Distributor & Dealer
Organization

No. A /187

PETROL TANK

SEVEN

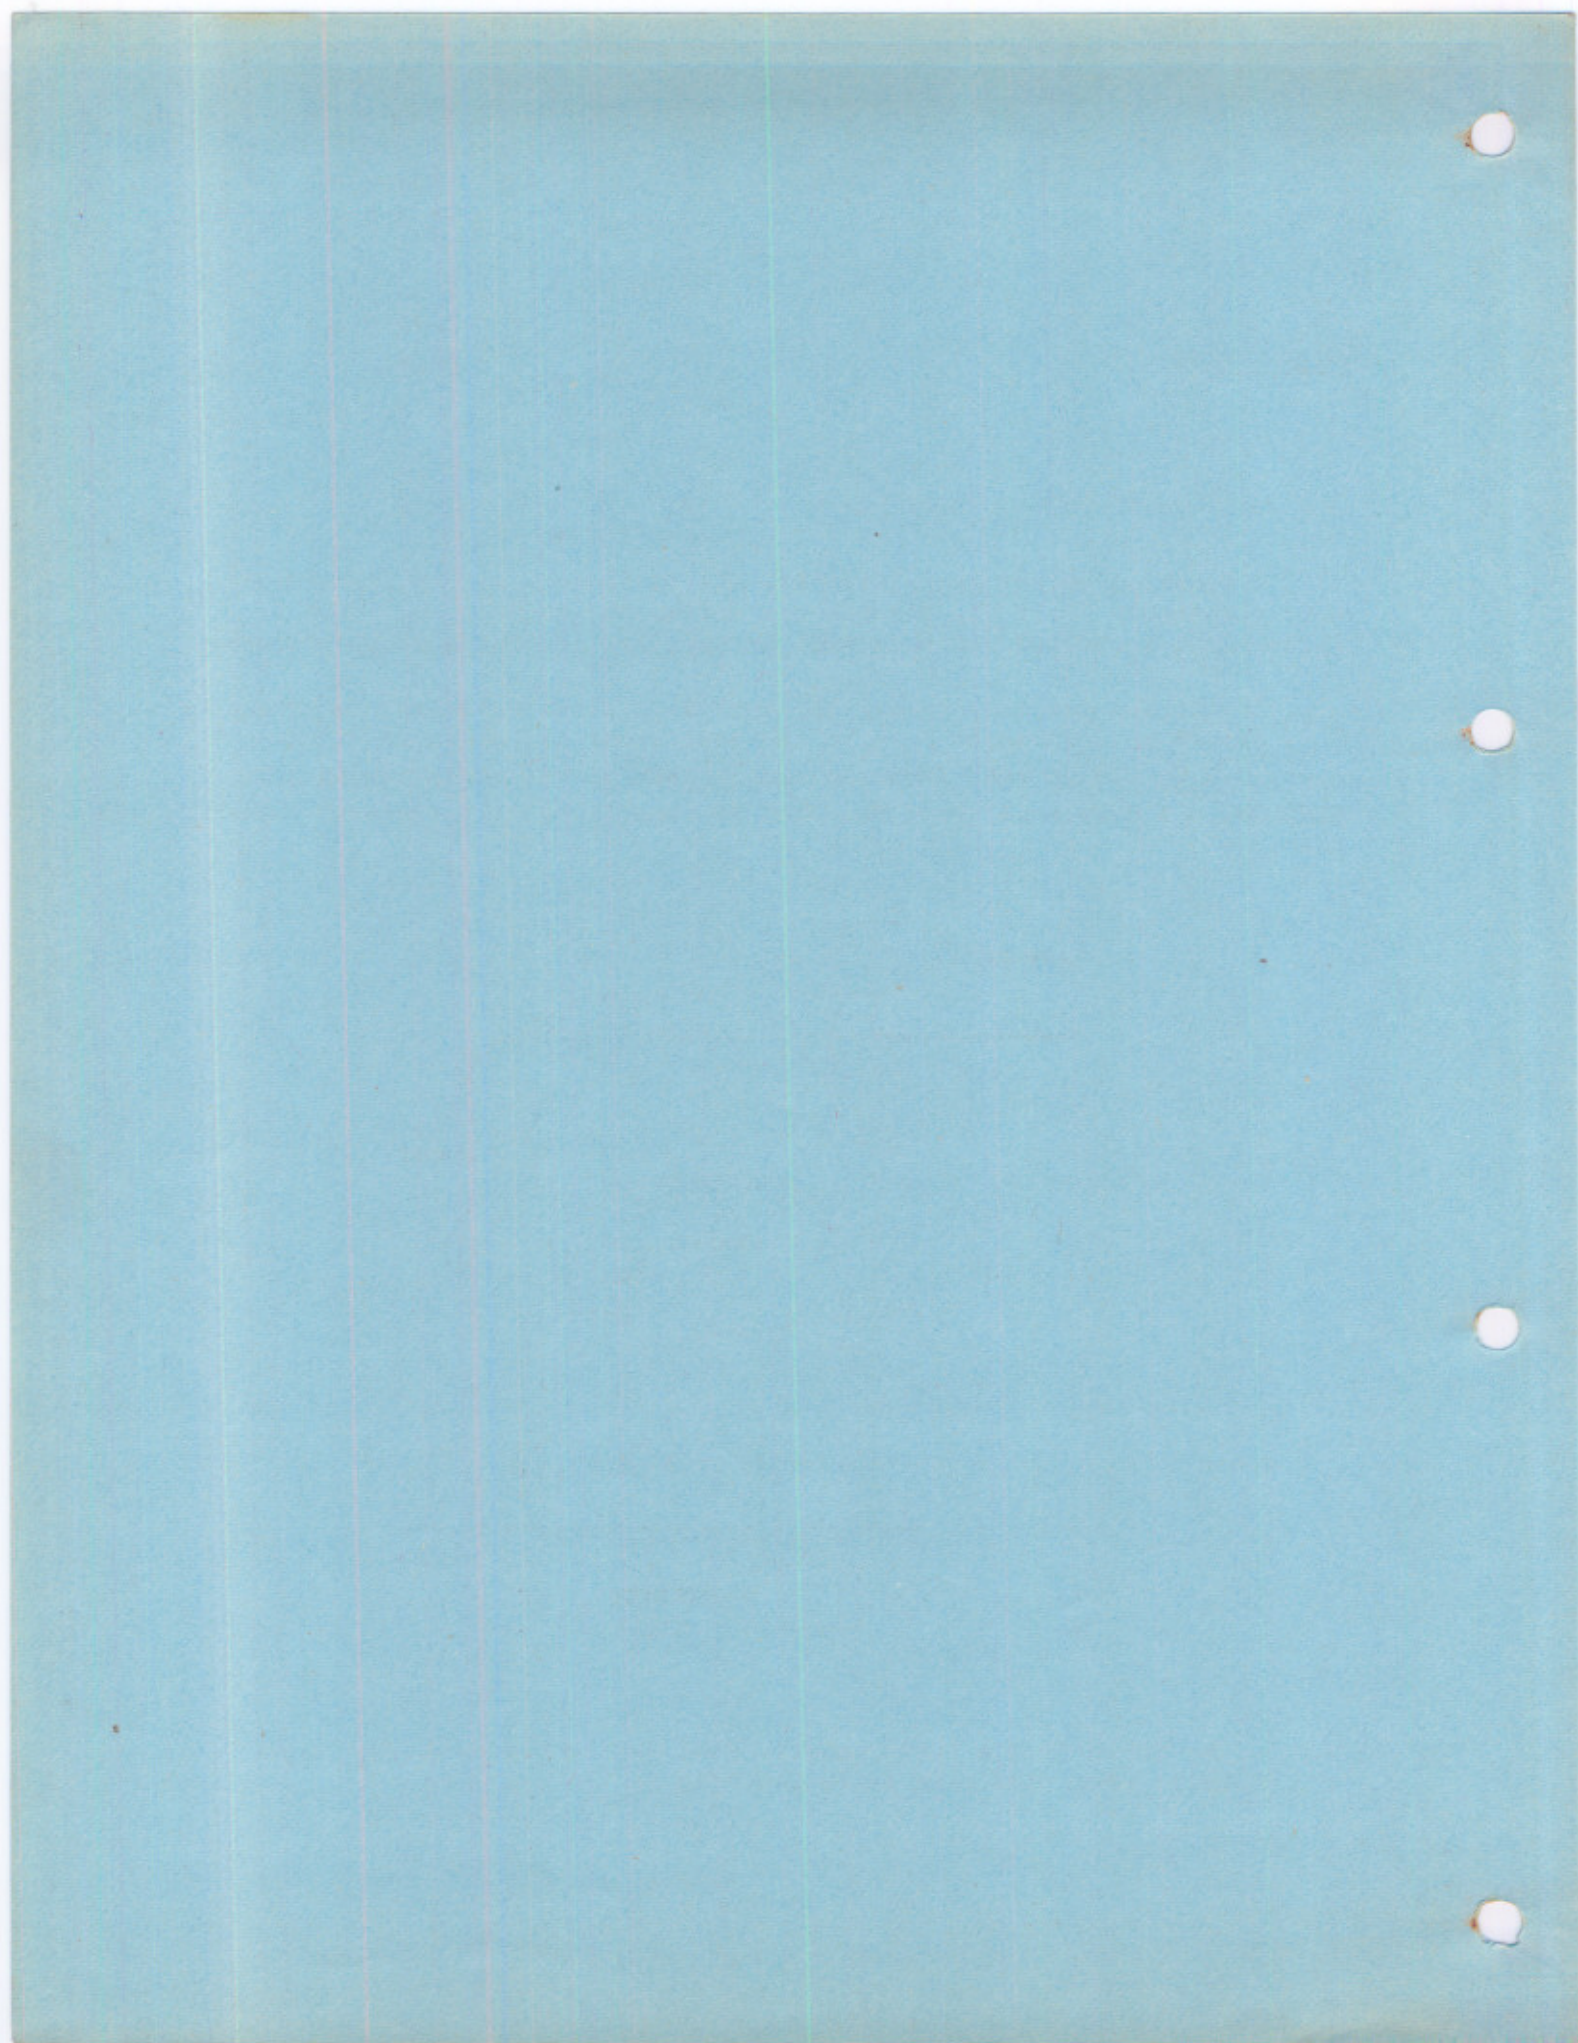
A modified petrol tank, Part No. ARA104, incorporating a drain plug & tube assembly, Part No. 21A352, was introduced at Body No. 10906 (plus 10811 to 10900) and this must be used for all service replacements.

To fit the new tank to earlier cars it will be necessary to provide a $1 \frac{1}{16}$ (26.99 mm.) diameter hole in the boot floor (as shown at 'A' in sketch) $3 \frac{1}{32}$ (76.99 mm.) from the centre line of the strap fixing bolt HZS0506. A dust seal, Part No. ARA1160, should be fitted around this hole.

N.B. The drain plug & tube assembly must not be fitted to the tank until after the tank is in position in the vehicle.

PETROL TANK - WATER ENTRY

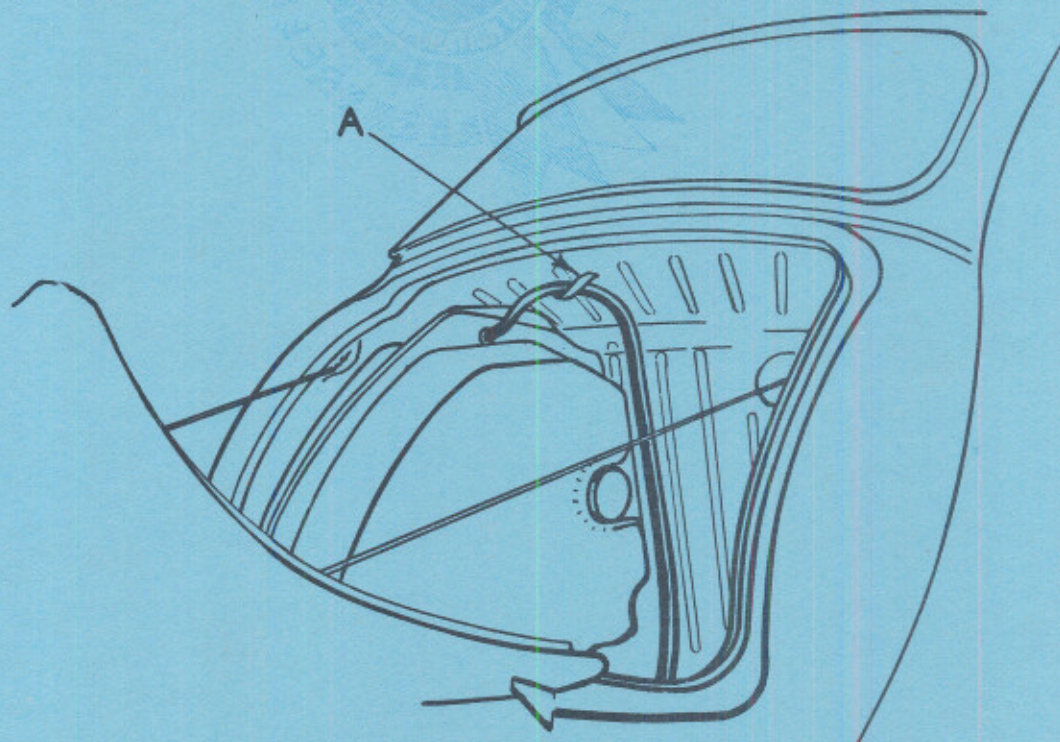
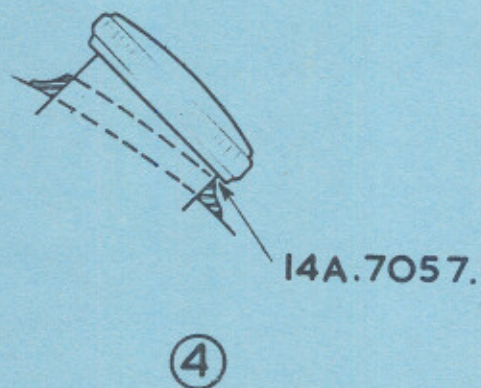
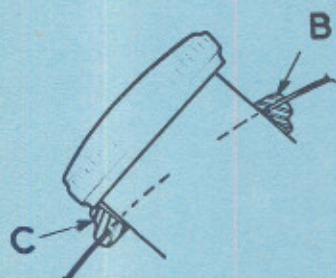
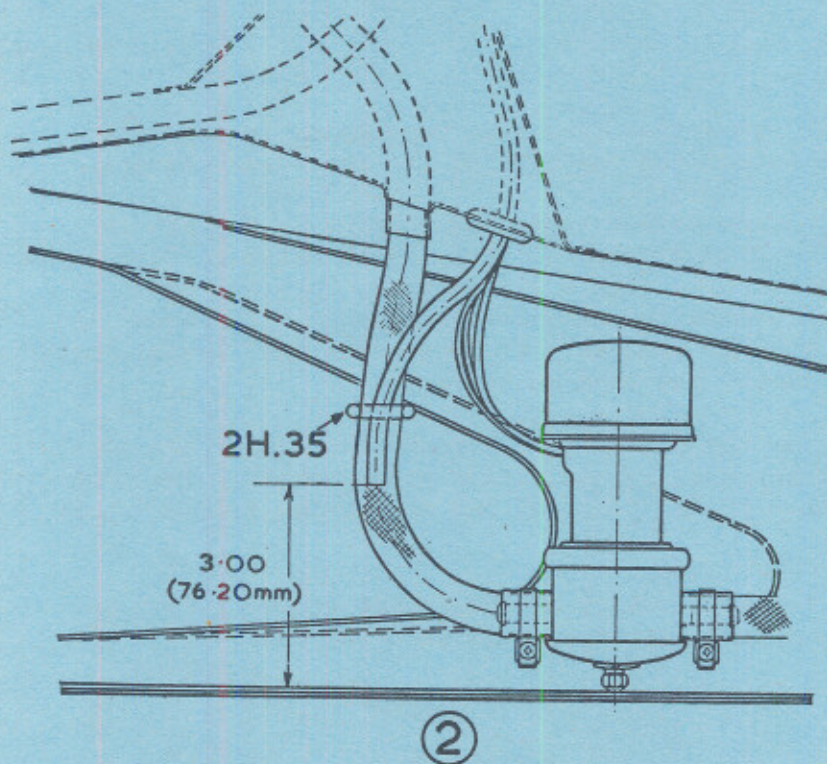
This may be due to the petrol tank vent pipe being incorrectly positioned and drawing water from the base of the sub-frame channel.

Water may also enter the petrol tank through the filler cap if it is prevented from seating properly by the filler pipe grommet. The grommet should be fitted as shown at 'B' (Fig. 3) and not upside down as shown at 'C'.

Fig. 4 shows the correct fitting of the latest grommet, Part No. 14A7057, introduced to prevent water leakage into the boot.

The vent pipe should be re-positioned by looping it as high as possible in the boot, utilising clip 'A' (Fig. 1) if fitted. Secure end of pipe to flexible petrol pipe with a rubber ring, Part No. 2H35, approximately 3" (76 mm.) from the base of the sub-frame (as shown in Fig. 2 overleaf). It will be necessary to disconnect the flexible petrol pipe from the pump to thread the ring on to it.

CARBURETTER PISTON ROD -

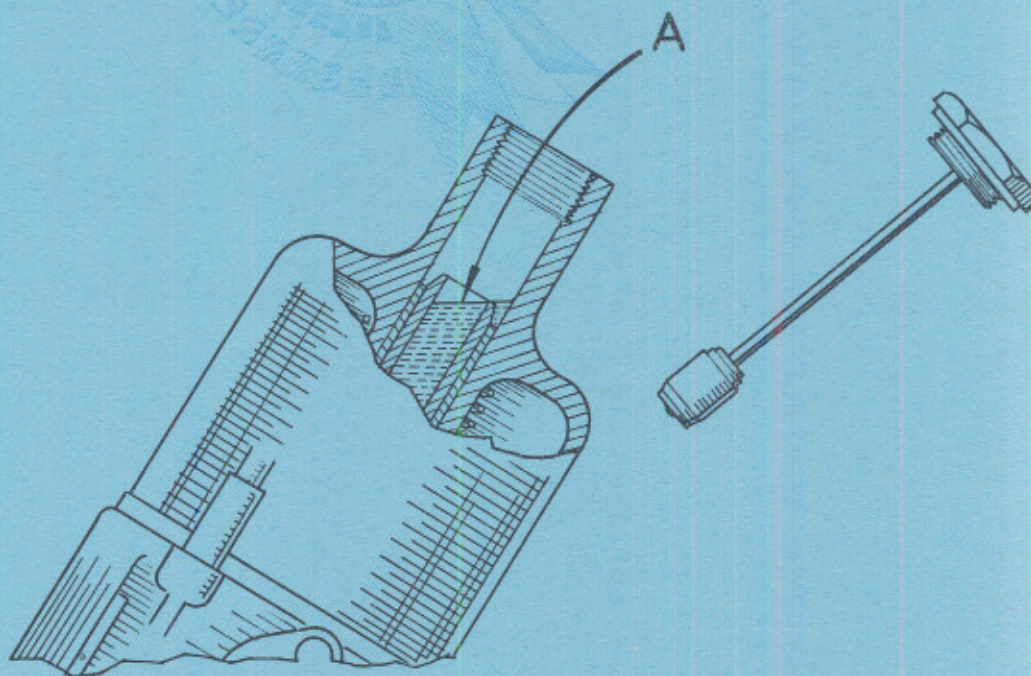
If corrosion and sticking of the rod are to be avoided, the oil level in the reservoir must not be allowed to fall below the level indicated at 'A' in the sketch below.

Only S.A.E. 20 oil must be used, whatever the climatic conditions.

STIFF GEAR CHANGE

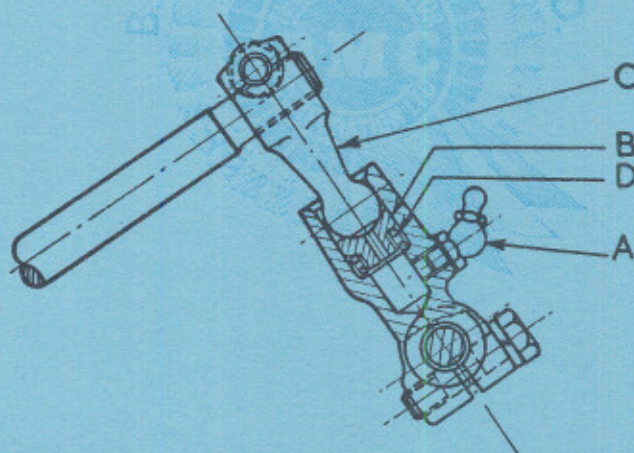
This may be caused by over-lubrication of remote control shaft lever grease nipple 'A', which would result in grease being packed behind thrust button 'B', thus putting considerable end-thrust on lever 'C'.

Thrust button 'B' and spring 'D' were deleted at Engine No. 8A-U-H6612 to prevent this possibility.

As removal of the thrust button is a considerable operation involving taking out the power unit, it is recommended that the grease nipple 'A' be removed from cars in service to prevent pressure lubrication at this point.

REAR SHOCK-ABSORBER

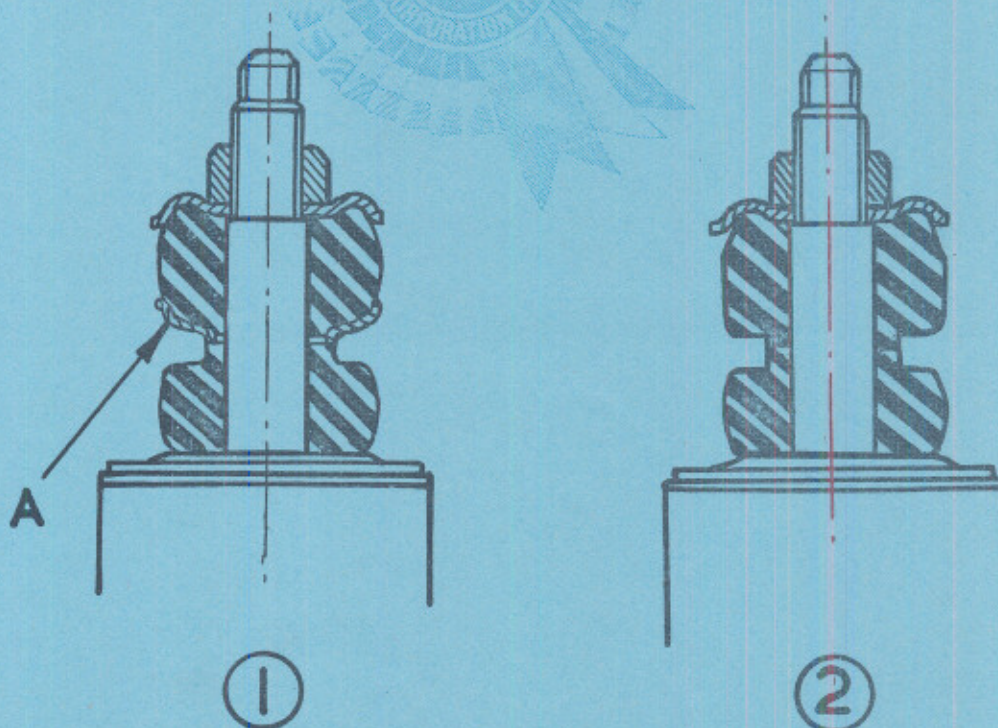
A revised top mounting rubber has been introduced for the rear shock-absorber of this model.

If it is necessary to fit the latest type top rubber in place of the old pattern, the washer 'A' will not be required and should be discarded. Both shock-absorbers should, preferably, have the same type top rubber fitted.

Fig. 1 below shows the old arrangement, and Fig. 2 the new.

Only the latest type top rubber, Part No. 27H1865 (Armstrong), 17H4733 (Girling), will be supplied for service, although shock-absorber assemblies may have either type fitted.

INADEQUATE DEMISTING

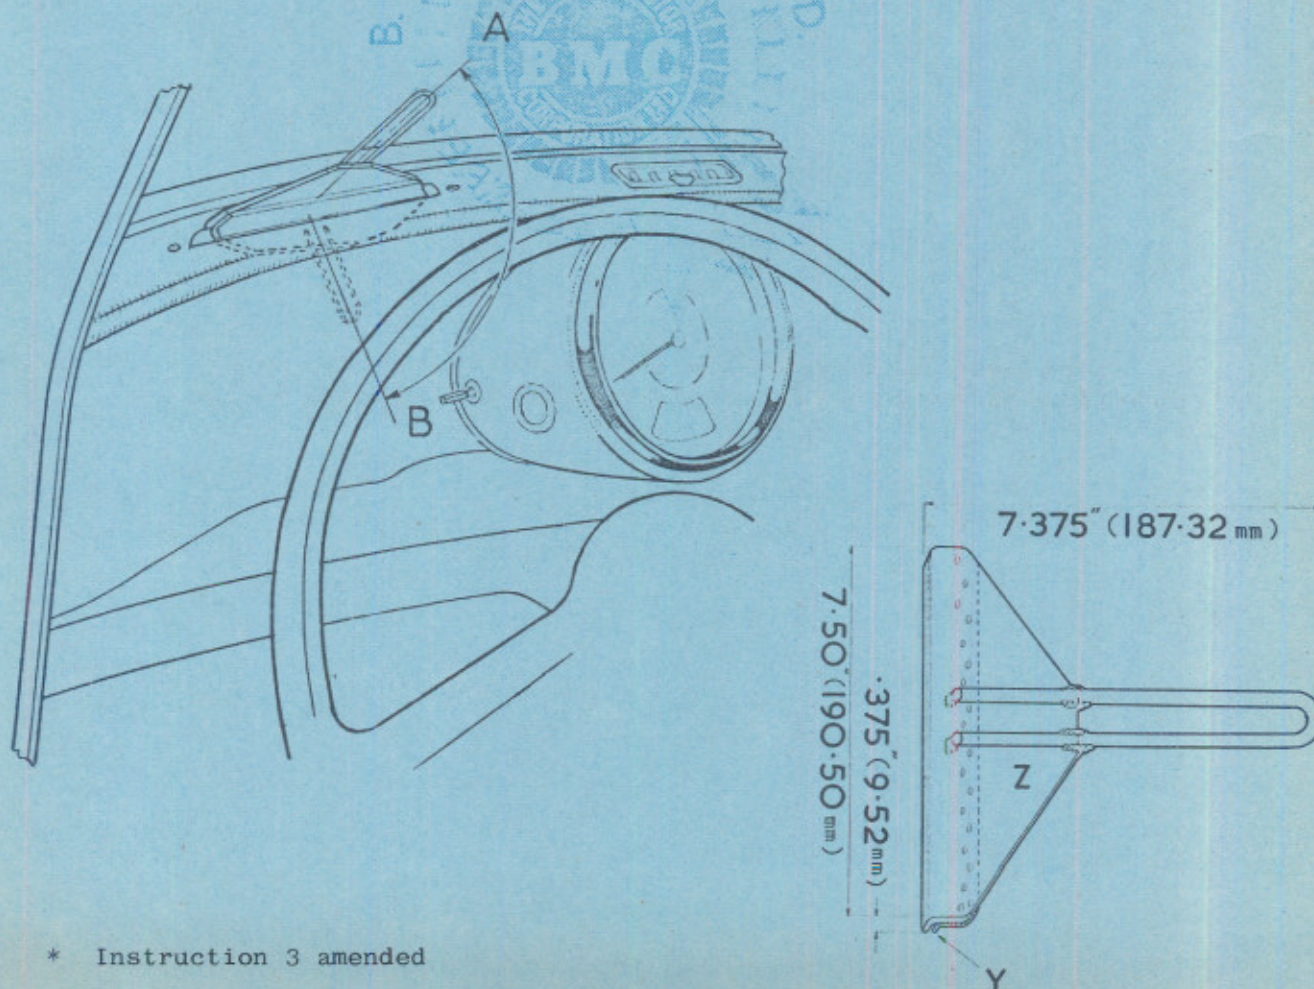
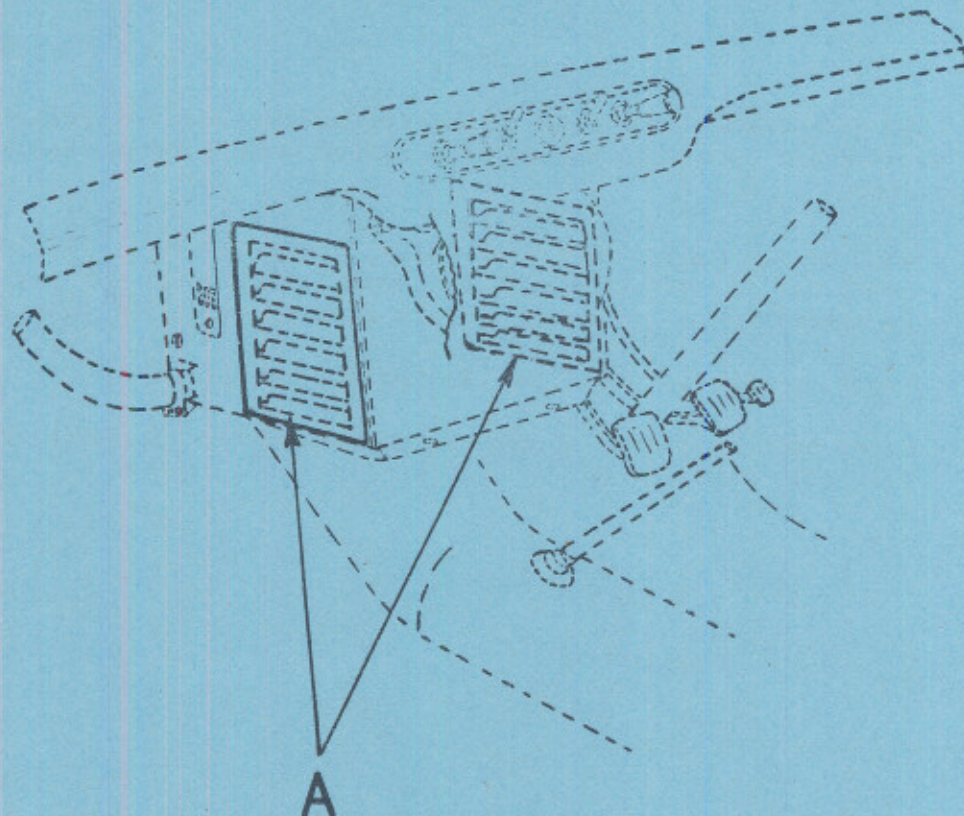
In cases where demisting is unsatisfactory, the following operation is recommended to enable air to be directed over a larger area of the windscreen:

1. Make up the tool illustrated below, using 10 S.W.G. (3.25 mm.) mild steel for 'Z' and 13 S.W.G. (2.33 mm.) mild steel for jaw 'Y', which is welded to 'Z' as shown. Take care to round and smooth all edges.
2. Position jaws of tool over the demister as at 'A'.
3. Press down on handle of tool to position 'B', i.e. until contact is just made with fascia.

* Instruction 3 amended

Demisting of the windscreen can be further improved if the heater louvres 'A' are blanked with 4" x 2" (say, 100 x 50 mm.) black waterproof adhesive tape.

FITTING STIFFENING BRACKET

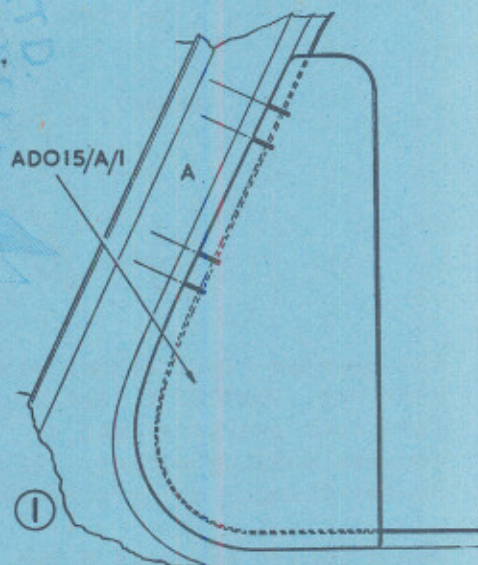
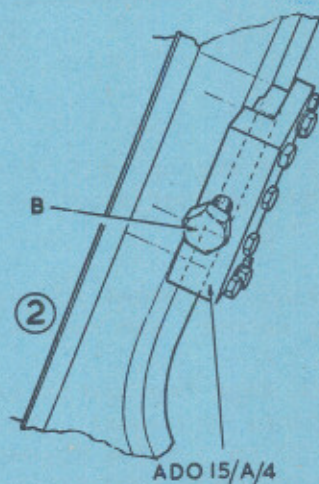
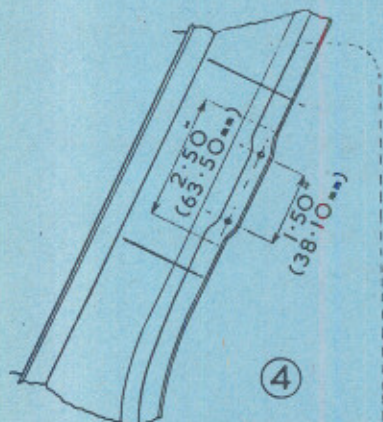
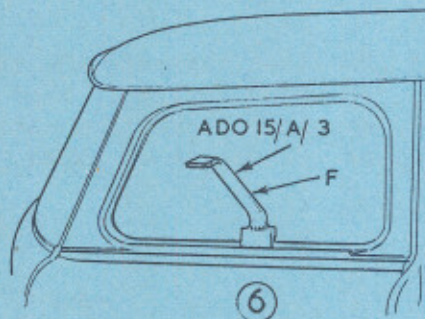
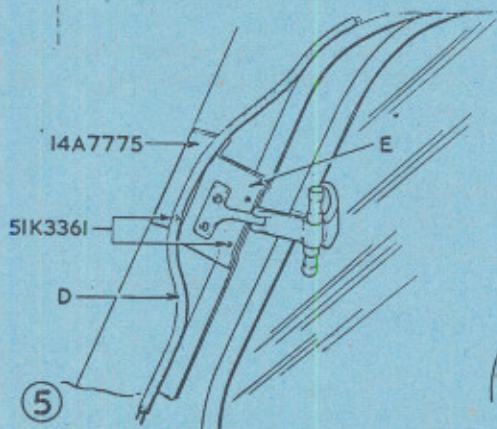
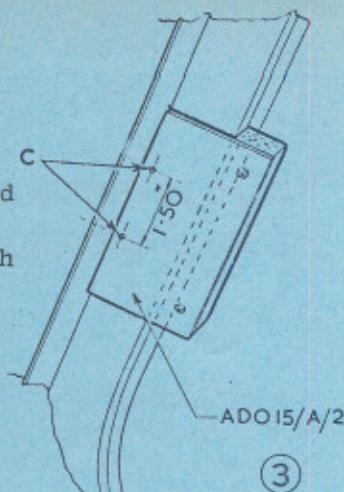
Commencing at Body No. 4046, an additional bracket, Part No. 14A7775, was introduced to improve the stability of the quarter-light catch operation. All bodies prior to this number should be modified as detailed below:

- (1) Remove the two screws securing hinged quarter-light catch to body panel, and fold back quarter-light against front door.
- (2) Remove quarter-light rubber seal.
- (3) Bend back trim towards back-light (great care must be taken not to crease material). This will reveal existing catch bracket, which need not be disturbed.
- (4) Position template ADO.15/A/1 on panel 'A' as shown in Fig.1; then with a pencil continue lines from slots in template on to outside of panel.

- (5) Line up tool ADO.15/A/4 with the two pencil marks, as in Fig. 2, then screw in bolt 'B' to produce an indent on flange. Remove tool.

- (6) Place drill jig ADO.15/A/2 in position, as shown in Fig. 3, and mark panel with a pencil through holes.
- (7) Position bracket, Part No. 14A7775, on indent produced by operation 5. Secure front end of bracket with a 'G' clamp and drill two .125" (3.17 mm.) holes through flange and bracket (Fig. 4).

Fit "pop" rivets, Part No. 51K3361. Slightly set 'G' clamp so that bracket (rear end) touches inside of panel, ensuring that the main body harness 'D' is positioned as shown in Fig. 5. Drill the two rear .125" (3.17 mm.) holes 'C', Fig. 3, (previously marked during operation 6). Fit "pop" rivets, remove 'G' clamp and finally peen "pop" rivet heads from inside ('E', Fig. 5).

- (8) Fit quarter-light rubber seal, Part Nos. 14A7326 & 14A7327, fold back quarter-light to "shut" position, ensuring that frame touches sealing rubber. If necessary, remove rubber seal and re-set flange, using tool ADO.15/A/3 ('F' Fig. 6).
- (9) Apply Dunlop adhesive S.758, Part No. 97H2152, to panel flange, renew (if necessary) quarter-light sealing rubber, and re-position trim.
- (10) With quarter-light in "shut" position, check that top and bottom clearances between window frame and body panel are equal. Move catch to "shut" position and drill two .109" (2.77 mm.) holes through catch, trim and bracket, TAKING CARE NOT TO DRILL THROUGH BODY PANEL. Fit catch retaining screws.
